ZTE CORPORATION

Change Description

FCCID: SRQ-Z2335CC

Model: Z2335CC

QM215 high-level block diagram and 720 BNSP package outline drawing

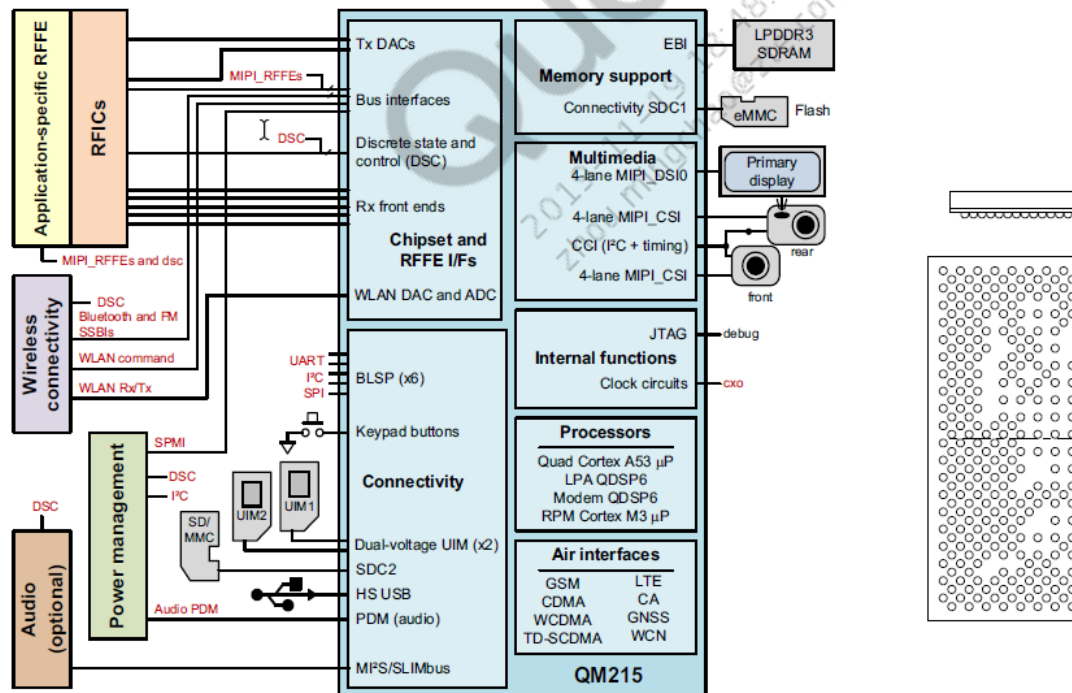
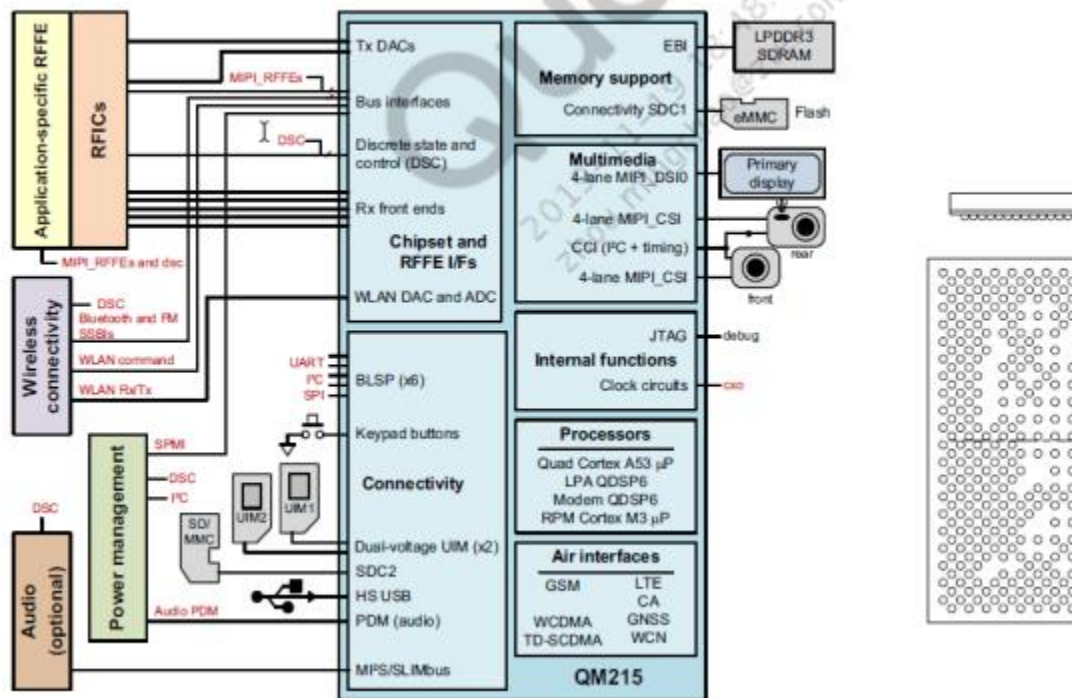
Notes: The new chip component is pin to pin compatible(approximately the same as chip of PCB) and no change in radio parameters has occurred, and has the same basic function as the QM-215-3-AB, Baseline version release notes as following.

Patent Chip	Variant Chip
Model	QM-215-3-AB	QM-215-0-AA
Product	QM215	QM215
Hardware changes	No Changes	
Software changes 1	5-mode cat4	4-mode cat4(delete the CDMA mode)
Software changes 2	Cortex-A53 1.3GHz	Cortex-A53 1.2GHz
Software changes 3	672MHz DDR	600MHz DDR

Software changes 4	HD+ 1440*720 display	qHD 960*540 display
Block diagram	As follows
